UNITED STATES
NUCLEAR REGULATORY COMMISSION
WASHINGTON, D. C. 20555

TURKEY POINT NUCLEAR GENERATING UNIT 3

Amendment No. 9
License No. DPR-31

CHANGE NO. 21 TO THE TECHNICAL SPECIFICATIONS

FIGURE 3.2-1

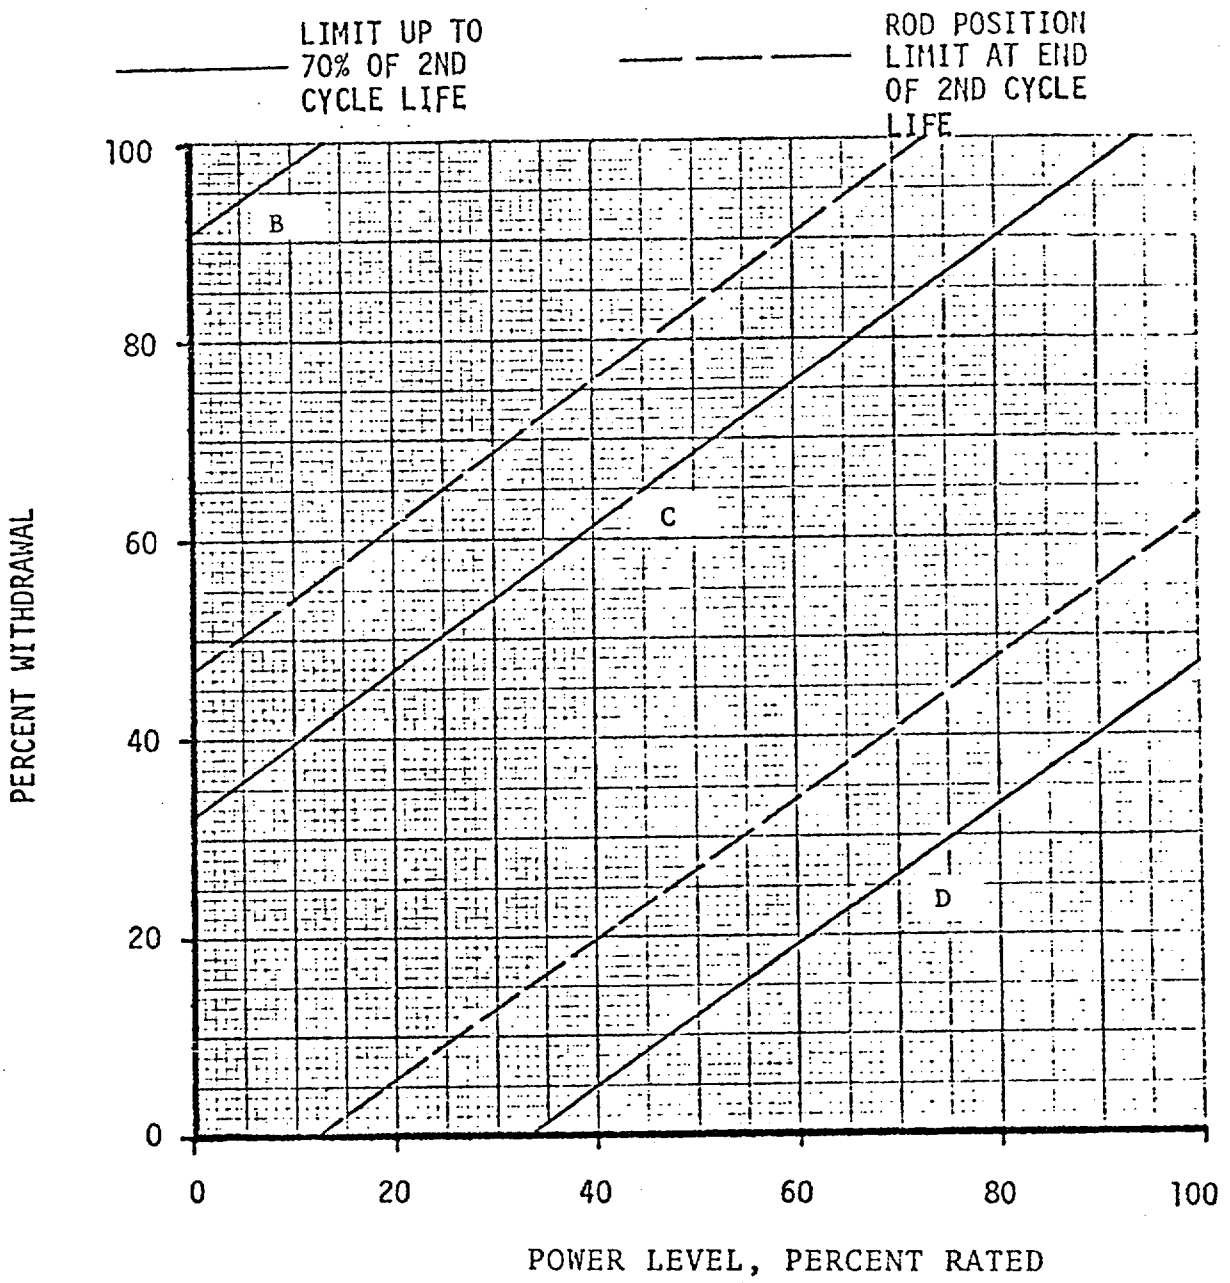
b. Whenever the reactor is critical, except for physics tests and control rod exercises, the control group rods shall be no further inserted than the limits shown by the solid lines on Figure 3.2-1 for three loop operation and on Figure 3.2-1(a) for two loop operation. 2

c. After 70% of the second and subsequent cycles as defined by burnup, the limits shall be adjusted as a linear function of burnup toward the end-of-core life as shown by the dotted lines on Figure 3.2-1.

d. The end-of-core life limit shown on Figure 3.2-1 may be revised on the basis of physics calculations and physics data obtained during startup and subsequent operation.

FIGURE 3.2-1(a)

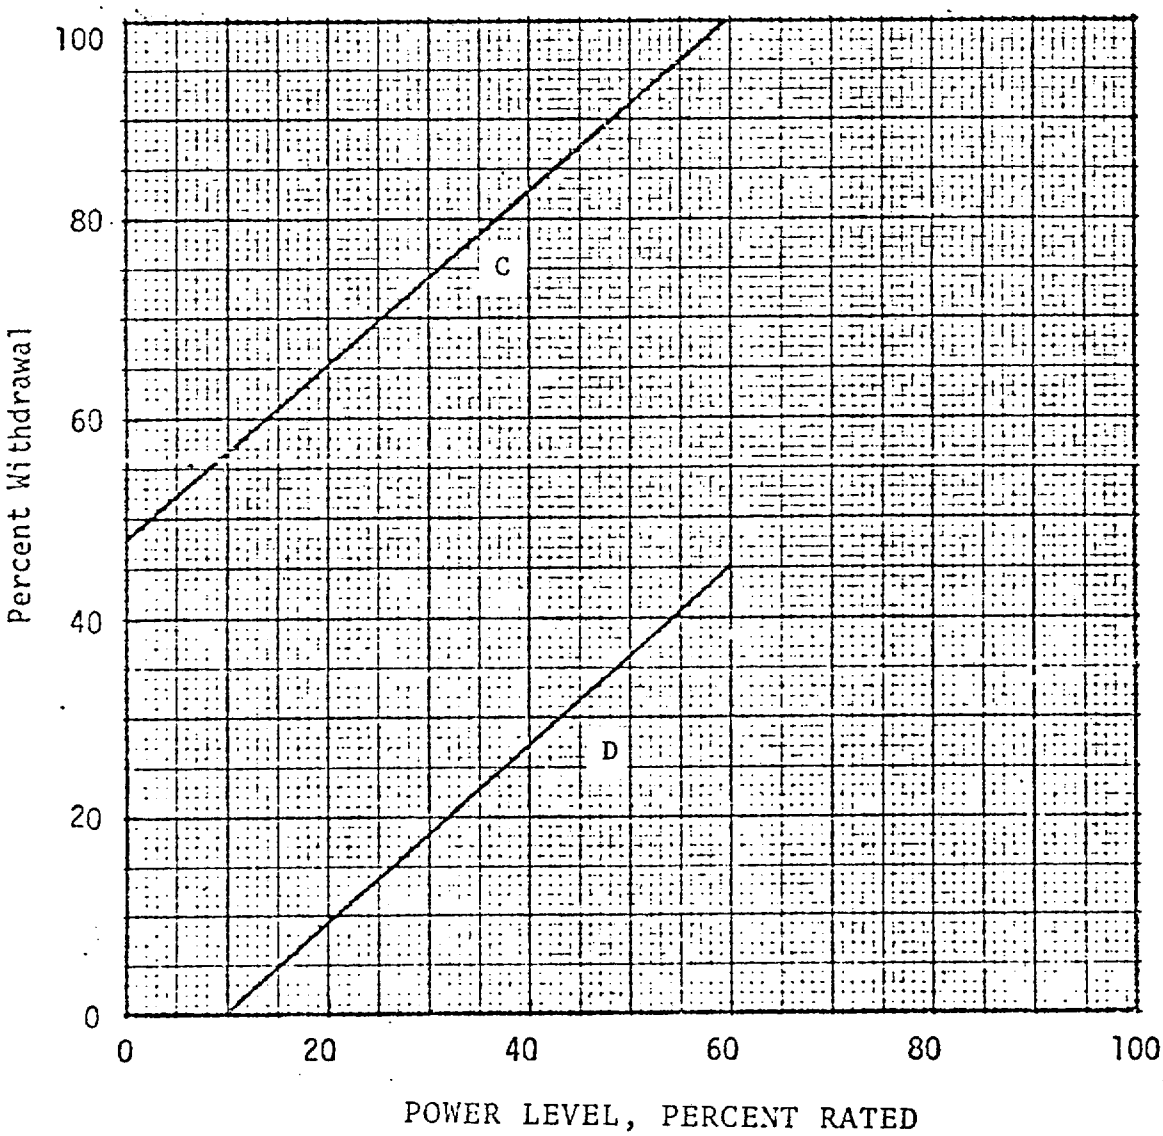
FPL has analyzed the control rod insertion limits for both three loop and two loop operation and has proposed Unit 4 control rod insertion limits for two loop operation which are more conservative than those presently specified. FPL has not proposed a change to the control rod insertion limits for three loop operation as their analysis shows the specified three loop insertion limits are more conservative than necessary. We have reviewed FPL's request and since we find that the use of the proposed presently specified three loop control rod insertion limits and the proposed two loop control rod insertion limits will not effect previously performed applicable safety analyses, we approve the proposed insertion limits. Use of the more conservative proposed control rod insertion limits will increase the minimum available shutdown margin, maintain an acceptable core power distribution, decrease the consequences of a control rod ejection accident and decrease the consequences of control rod misalignment.

Figure 3.2-3 HOT CHANNEL FACTOR NORMALIZED OPERATING ENVELOPE

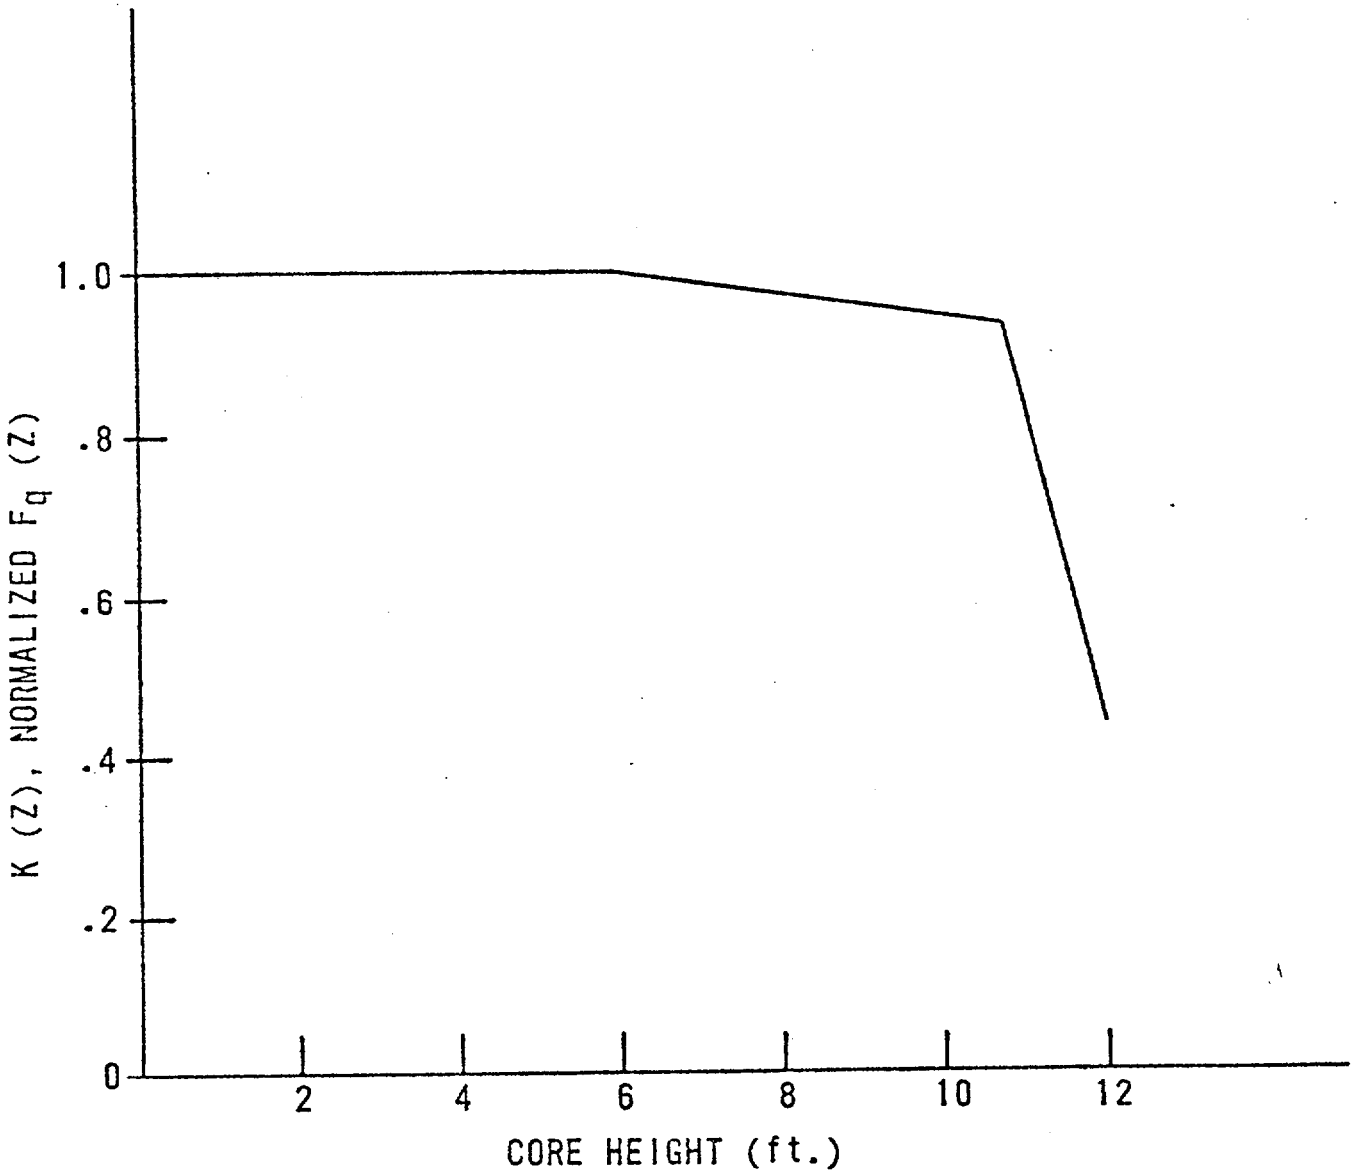
$F_q(Z) \leq (2.32/P) \times K(Z)$ for $P > .5$

$F_q(Z) \leq (4.64) \times K(Z)$ for $P \leq .5$

where P is the fraction of design power at which the core is operating. K(Z) is the function given in Figure 3.2-3 and Z is the core height location of F_q. 21

An upper bound envelope of 2.32 times the normalized peaking factor axial dependence of Figure 3.2-3 has been determined (from extensive analyses at design power considering all operating maneuvers) to be consistent with the technical specifications on power distribution control as given in Section 3.2. The results of the loss of coolant accident analyses based on this upper bound envelope indicate a peak clad temperature of 2150°F at design power, corresponding to a 50°F margin to the 2200°F FAC limit.
